EDINBURG CISD

ADDENDUM 3
CSP 23-02
UTRGV-EDINBURG CISD COLLEGIATE HIGH SCHOOL
October 3, 2022

This addendum is issued for the purpose of modifying the plans and specifications for the *UTRG/EDINBURG CISD COLLEGIATE HIGH SCHOOL*.

RCP LEGEND

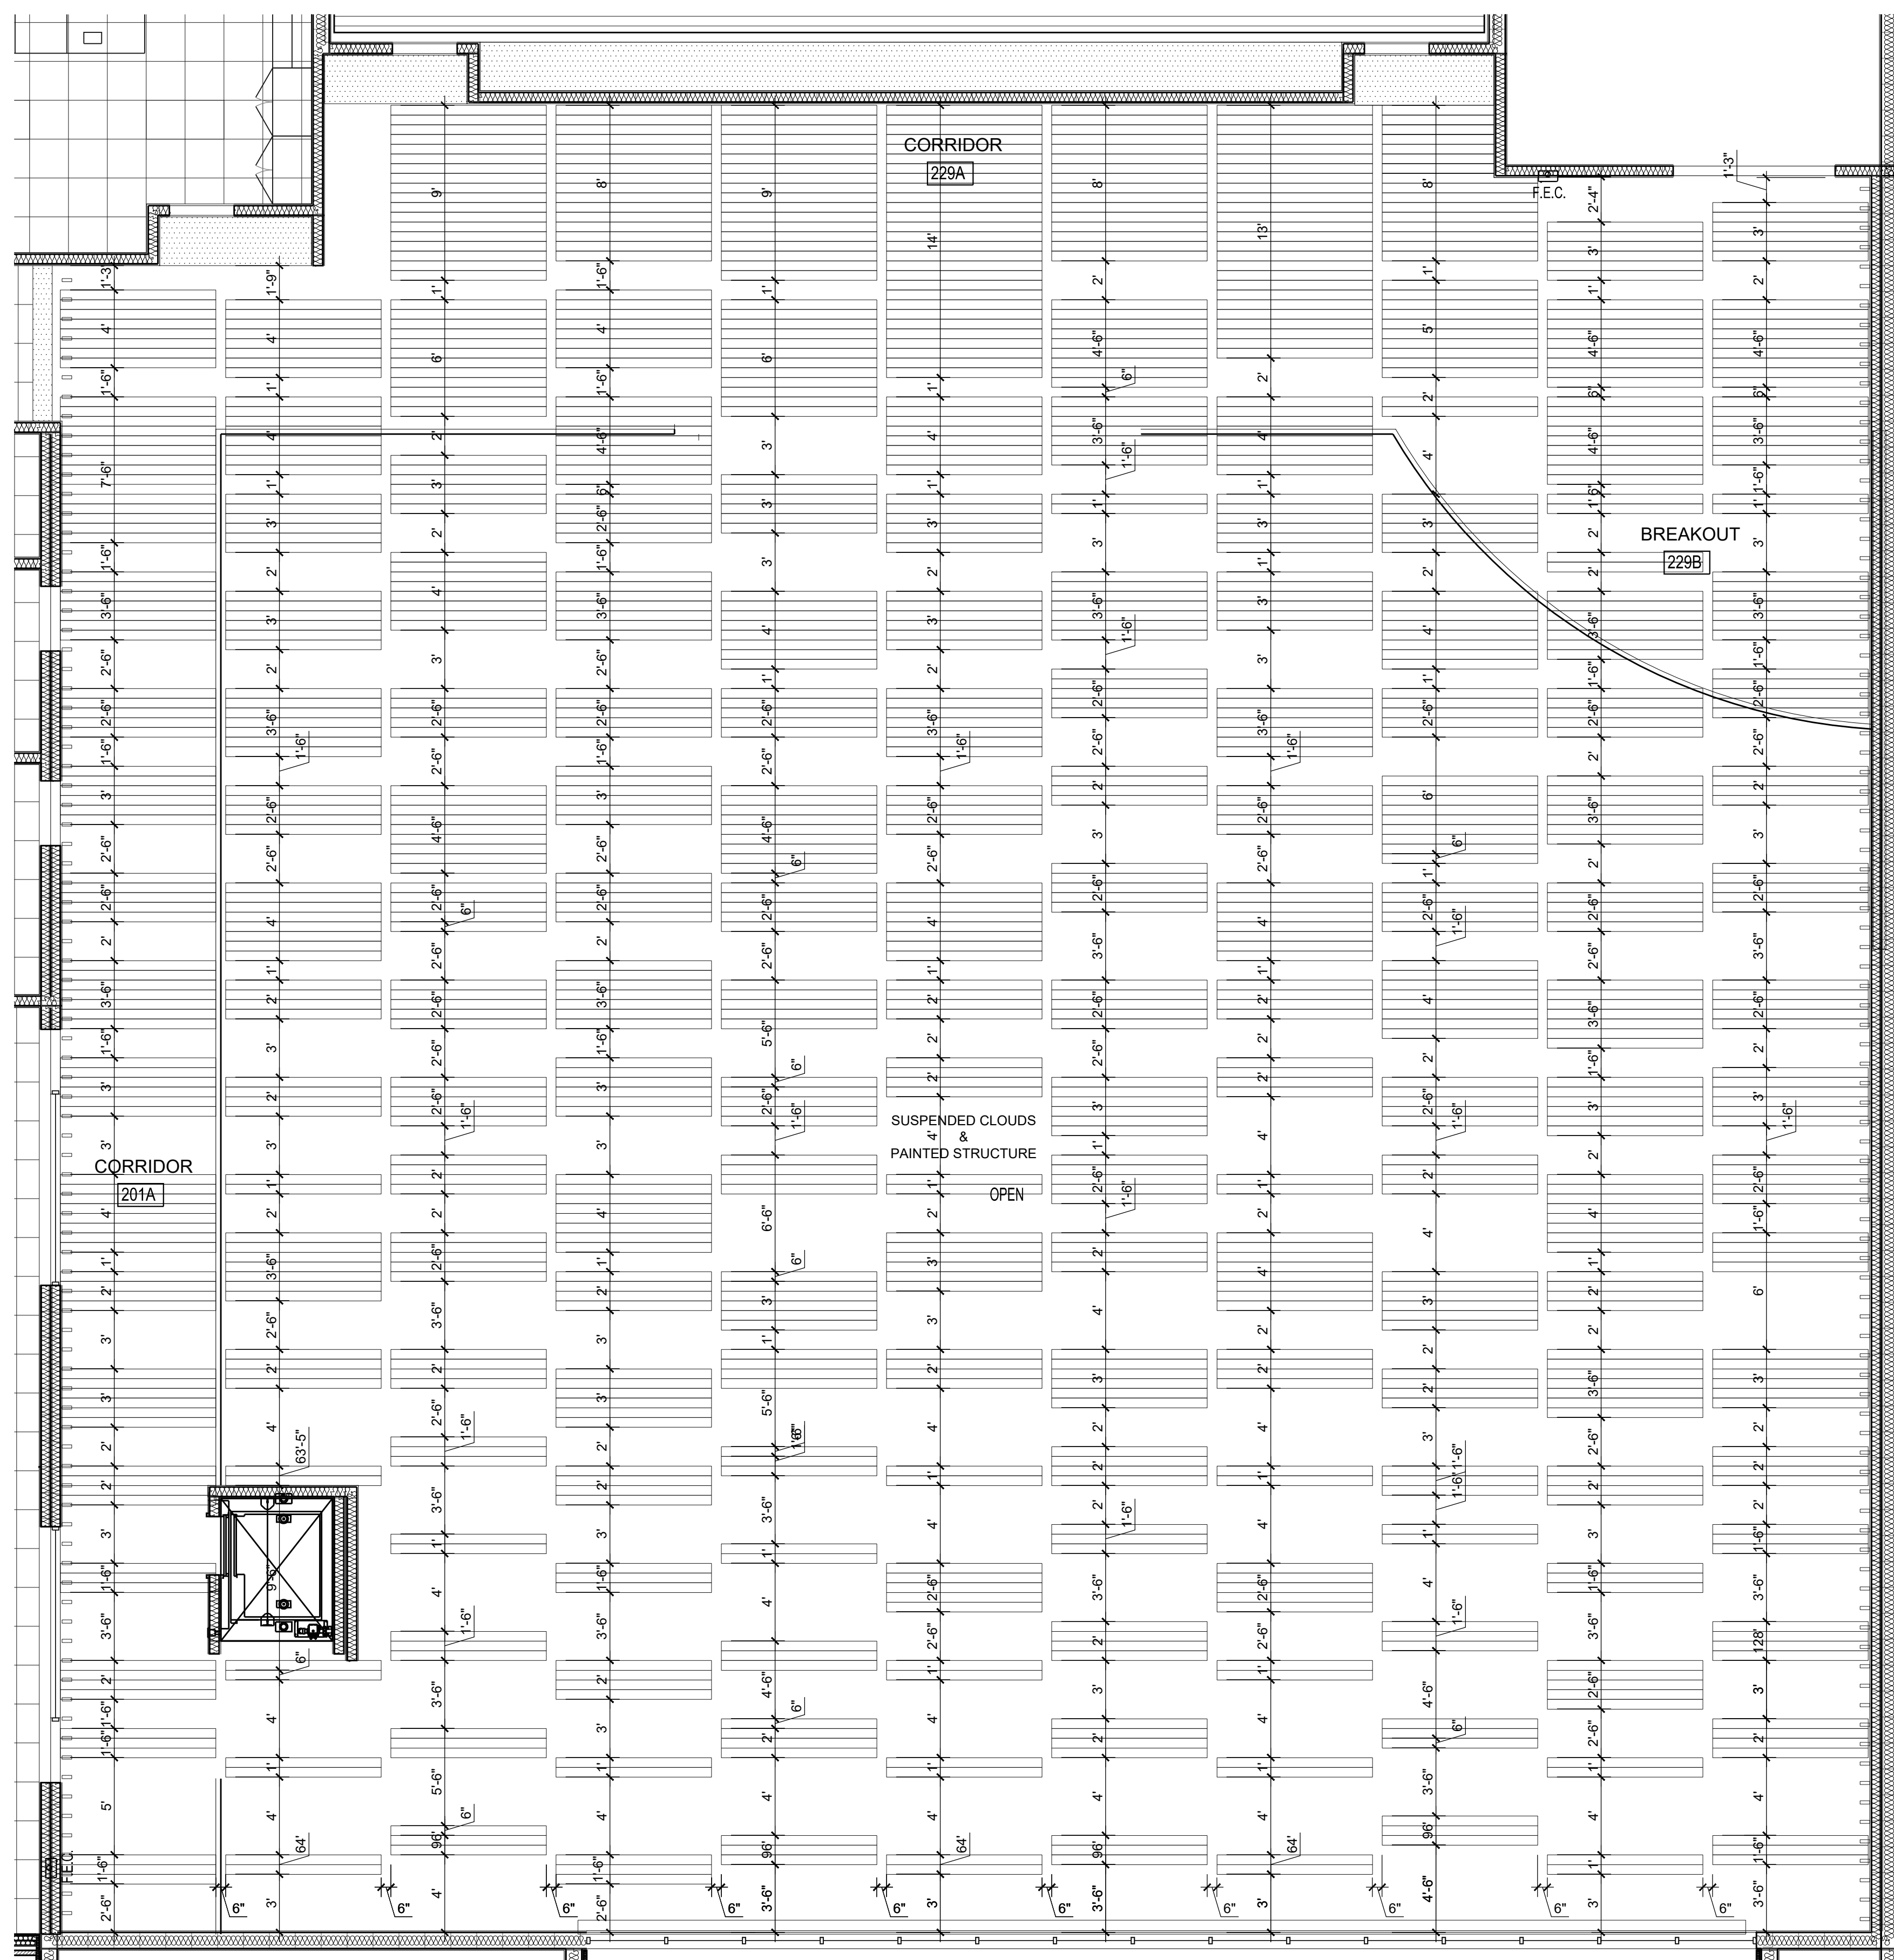
- c. Revise note for USG Celebration Torsion Spring System in lieu of Armstrong Metal Works Torsion Spring.
8. Sheet A2.10

- a. Revise note for USG True Wood Panels in lieu of Armstrong Acoustical Vertical Wall Panel.
 - b. Revise note for Vertical Baffels by Chroma Collections.com in lieu of Armstrong Metal Works.
 - c. Clarification at suspended wood clouds at Collaboration Space 170. Wood Clouds to be set at 30'-0" from first floor finish floor.
9. Sheet A2.11
- d. Revise note for USG True Wood Panels in lieu of Armstrong Acoustical Vertical Wall Panel.
10. Sheet A3.01
- a. Add Operable Partition
11. Sheet A3.15, A3.16, A3.17, A3.18 and A3.19
- a. Revisions to Stairs
12. Sheet A5.01
- a. Revisions to West Elevation windows and accent brick to accommodate operable partition.

© Copyright 2022
 Gomez Mendez Saenz Inc.
 Architects-Planners
 Interior Designers
 Date: September 08, 2022
 Scale: As Noted
 Project Architect: David Monreal, AIA
 Drawn By: P.M.
 Job No: 22073
 Sheet: M4.03

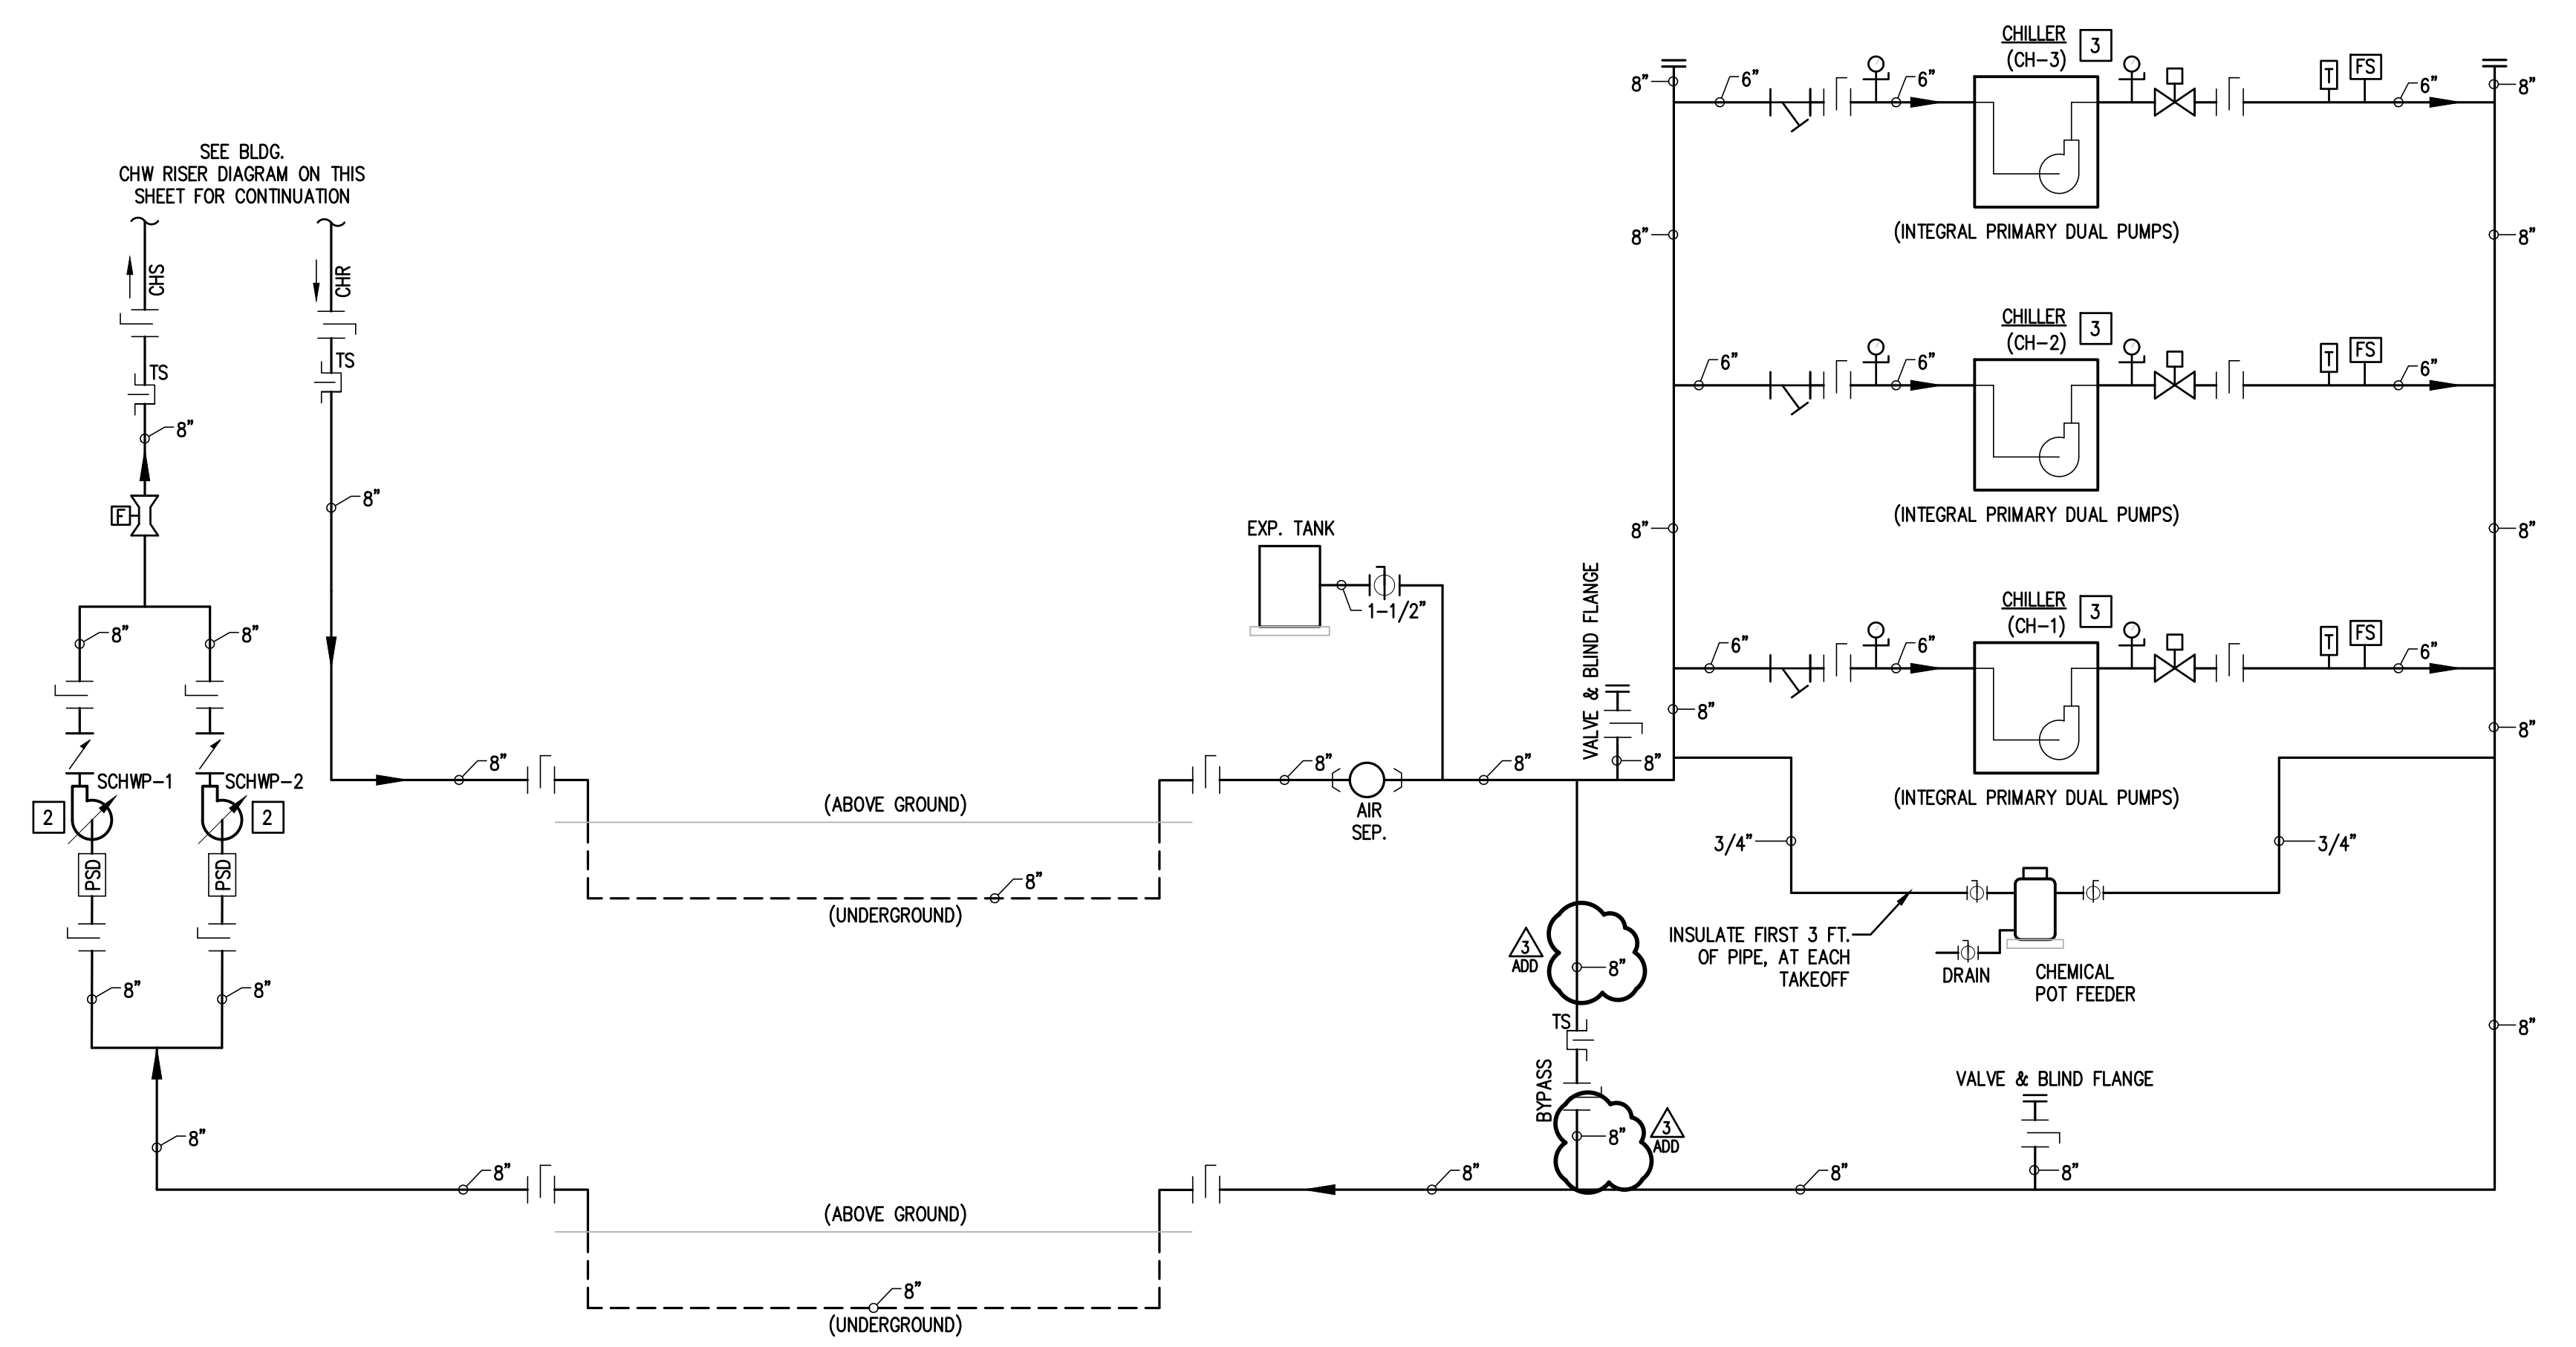
1. Sheet ES1.01:
 - a) Revised gate designations. See attached sheet.
2. Sheet M4.03:
 - a) Central Plant Chilled Water Schematic Diagram was revised. Bypass line increased in size from 6"Ø to 8"Ø. See attached sheet.
3. Sheet E3.01:
 - a) Revised lighting plan. See attached sheet.
4. Sheet E3.02:
 - a) Serving Line 156: Added 3 light fixtures type "A4" and lighting controls. See attached sheet.
5. Sheet E3.03:
 - a) Corridor 212A Stairwell: Adjust 2 light fixtures type "A2" & "A2E" 4'-0" plan south towards exterior wall.
6. Sheet E3.04:
 - a) Revised lighting plan and keyed notes. See attached sheet.
7. Sheet E4.01:
 - a) Revised electrical plan. See attached sheet.
8. Sheet E4.03:
 - a) Revised electrical plan. See attached sheet.
9. Sheet E4.04:
 - a) Revised electrical plan. See attached sheet.
10. Sheet E4.05:
 - a) Revised special systems plan. See attached sheet.
